RBW6405G12131-3G-1
Job Sheet 199906

DART AEROSPACE	
TITLE TOOL, T/R SLIDER BUSHING INSTALL (NEW STYLE BUSHING)	
DWG NO. RBW6405G12131-3G-1	REV 2
MAT'L WHITE DELRIN/ACETAL	UNLESS OTHERWISE SPECIFIED DIMENSIONS ARE IN INCHES
HEAT TREAT	.XXX ± .005 FRACTIONS ± 1/8
FINISH	.XX ± .01 ANGLES ± 5°
SPEC	.X ± .1 SURFACES = 125/
DRAWN BY: CLOUGH	1. BREAK ALL SHARP EDGES .015 x 45° OR .015R
CHECKED: DUERFELDT	2. DIMENSIONAL LIMITS APPLY AFTER PLATING
OPPS APPR: ANDERSON	3. INTERPRET DIM AND TOL PER ASME Y14.5M-2009
QA APPR: LINDSAY	USED ON MODEL
APPROVED: GILBERT	
SCALE 1:4	DATE 8/21/2015
SHEET 2 OF 5

(-1)
HANDLE

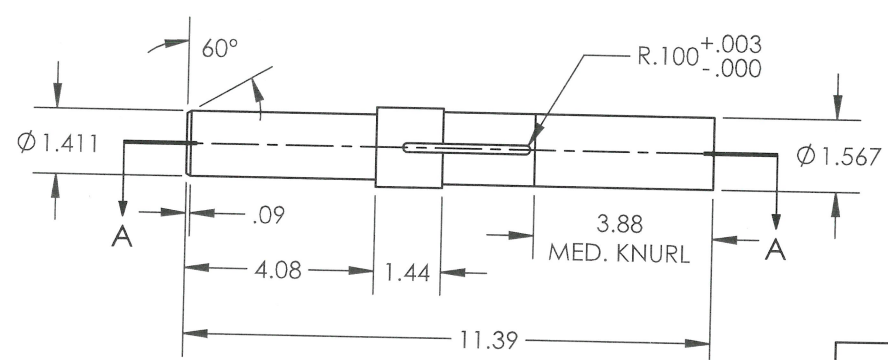
Dim. should be removed ~~and to add this dim.~~

This dim. can alter

0.940" +0/-0.005
